HISTORIC PRESERVATION COMMISSION

SUBJECT: Historic Area Work Permit #656085, rear screen porch enclosure, window replacement and other alterations

MONTGOMERY COUNTY HISTORIC PRESERVATION COMMISSION
STAFF REPORT

DAYS RESIDENCE

1
A.1 EXTERIOR ELEVATION - REAR
SCALE: 3/16" = 1'-0"

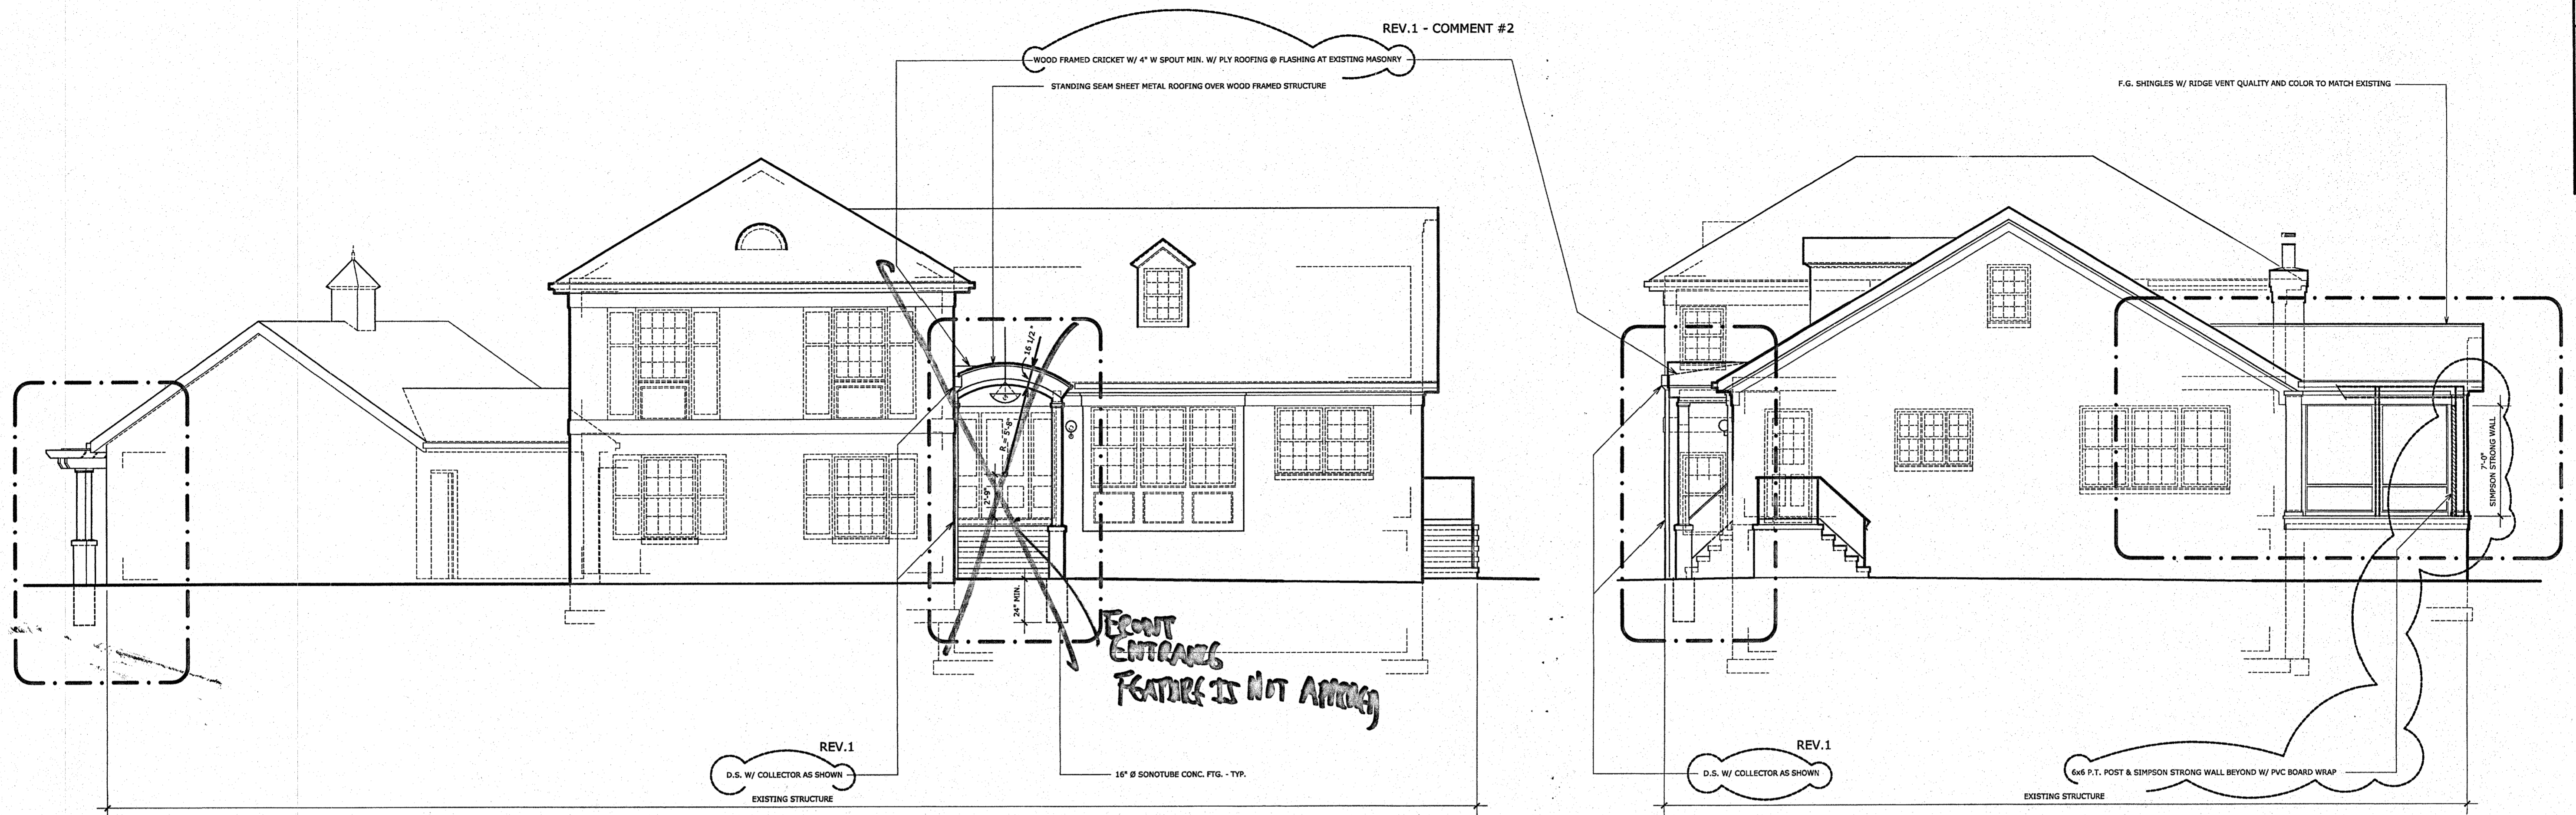
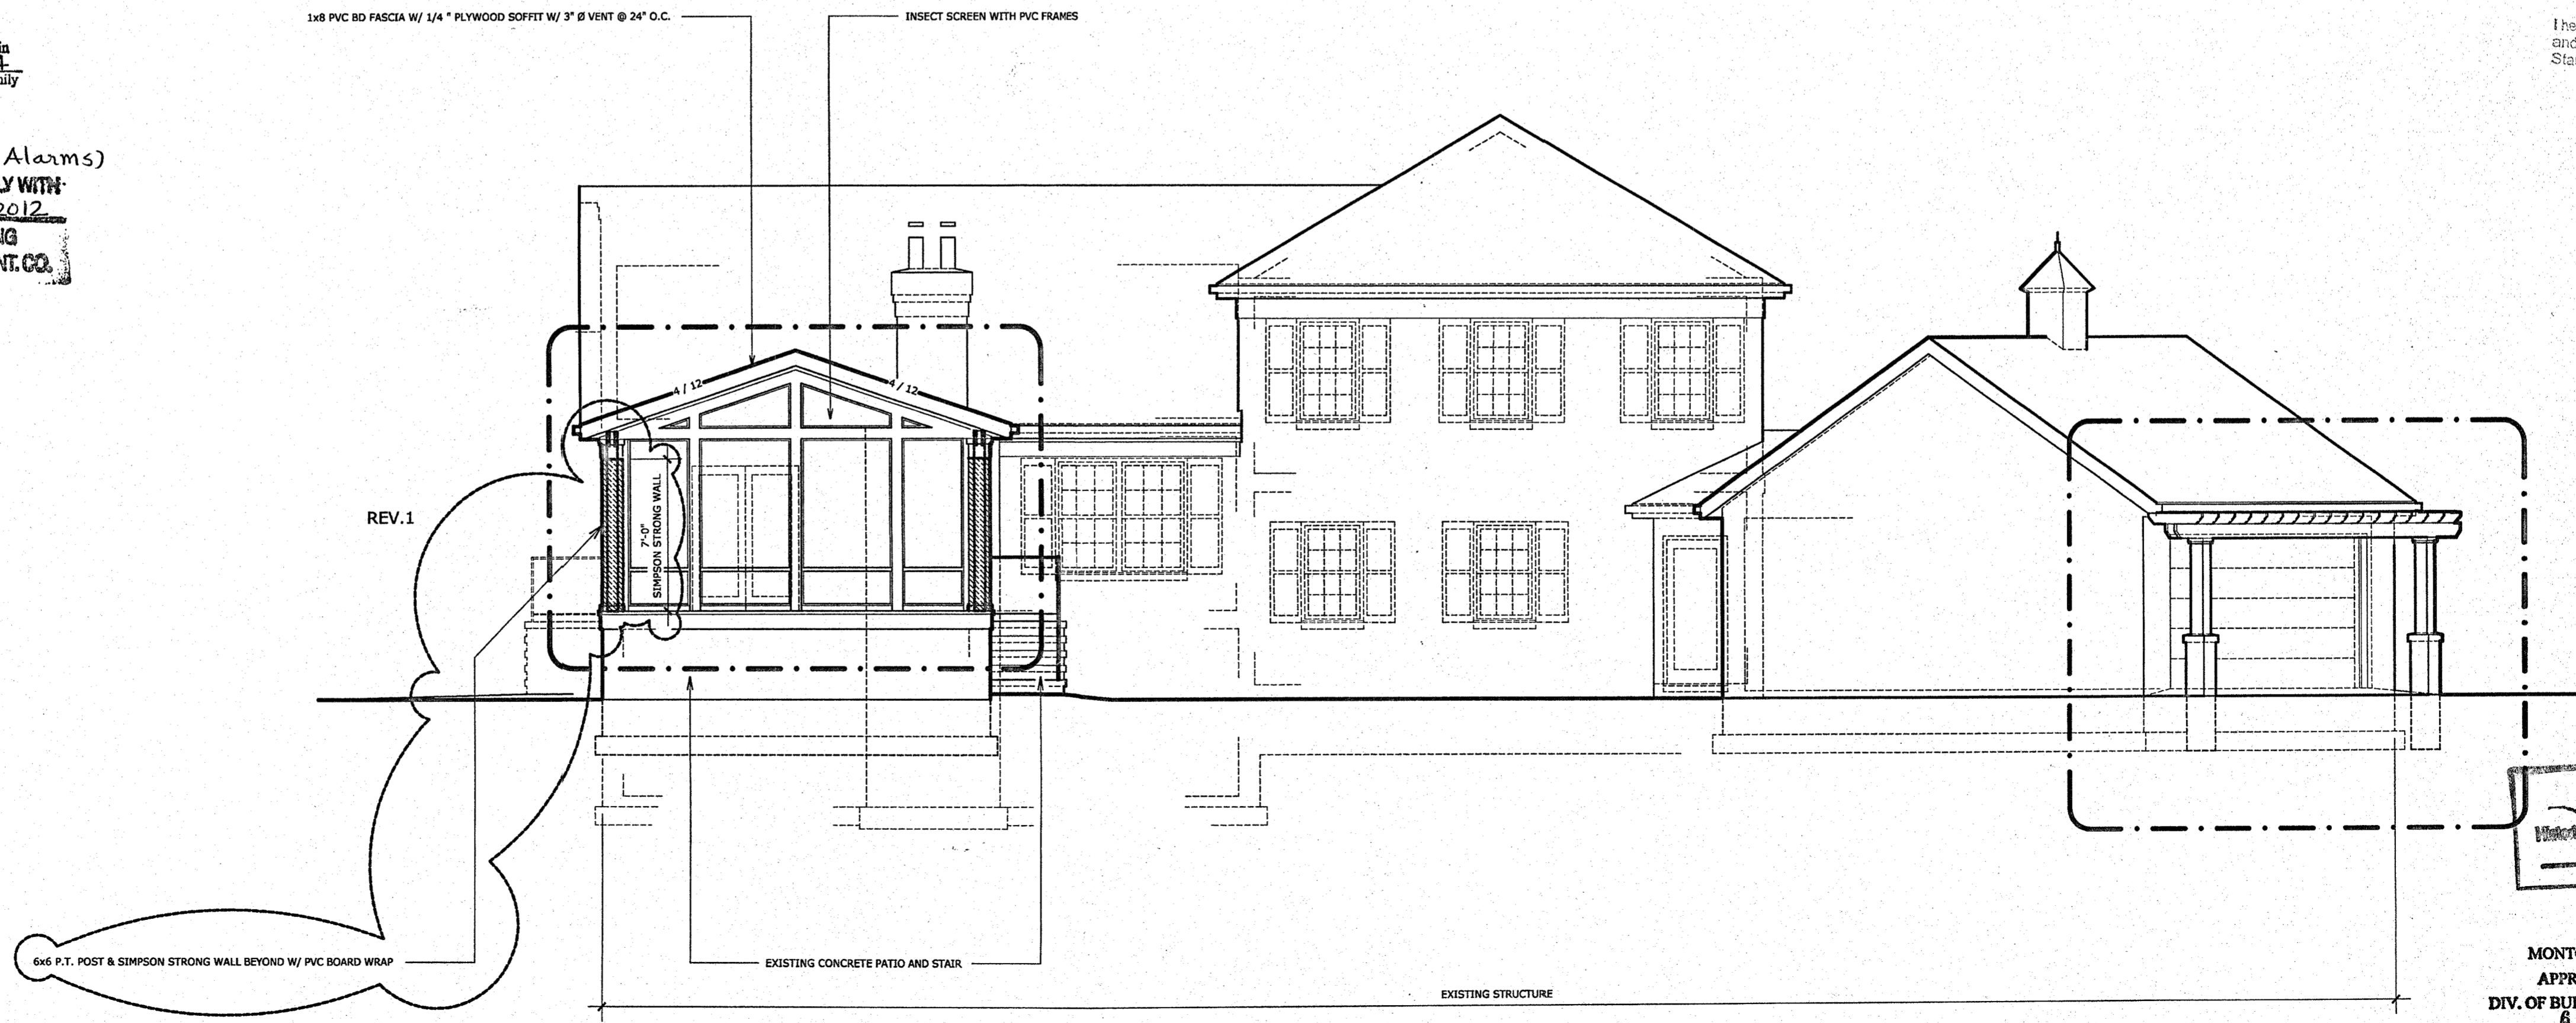
Smoke detectors shall be installed in accordance with Section R314 of the 2012 One and Two Family Dwelling Code as amended.

(Carbon Monoxide Alarms)
THESE PLANS MUST COMPLY WITH SECTION R315 OF THE 2012 1 & 2 FAMILY DWELLING CODE AS AMENDED BY MONT. CO.

Electrical wiring must conform to the 2008 National Electrical Code and County Requirements.

NOTE
THIS PERMIT DOES NOT INCLUDE APPROVAL FOR ANY ELECTRICAL WORK. YOU MUST HAVE A SEPARATE ELECTRICAL PERMIT TO DO ANY ELECTRICAL WORK.

GENERAL STRUCTURAL ARRANGEMENT APPROVED SUBJECT TO FURTHER APPROVAL OF CONSTRUCTION
